TECHNICAL INFORMATION

Date: 24.10.2023
 TI: 1423
 Machine type(s): Siamonie Smart

New grinder cover

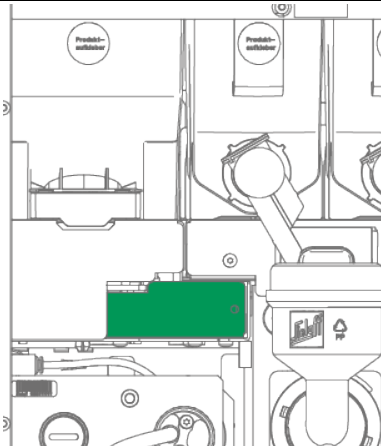
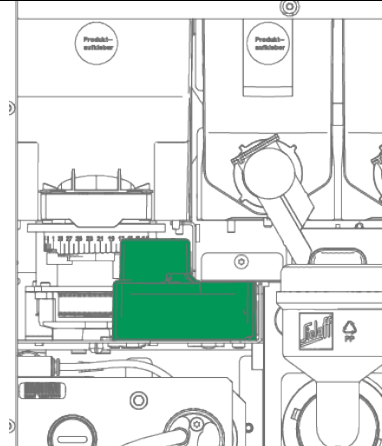
On the models from the Siamonie Smart series, the area between the grinder and the powder chute has been optimised.

A new grinder cover made from PA6 has been introduced to cover the area between the grinder outlet and powder chute more effectively. The new plastic cover replaces the metal one, sealing the machine area with a form-fit connection.

This change has also enabled us to integrate a feature for extracting any moisture that accumulates, as it has allowed us to create an opening for instant air extraction.

The new grinder cover will be fitted as standard from production week CW13/2023, machine serial number 90540613.

The cover can be retrofitted on older machines by using the following conversion kits:

4175033300	Mono grinder cover conversion kit	
4175033400	Duo grinder cover conversion kit	
4175033300	Mono XL grinder cover conversion kit	
4175033400	Duo XL grinder cover conversion kit
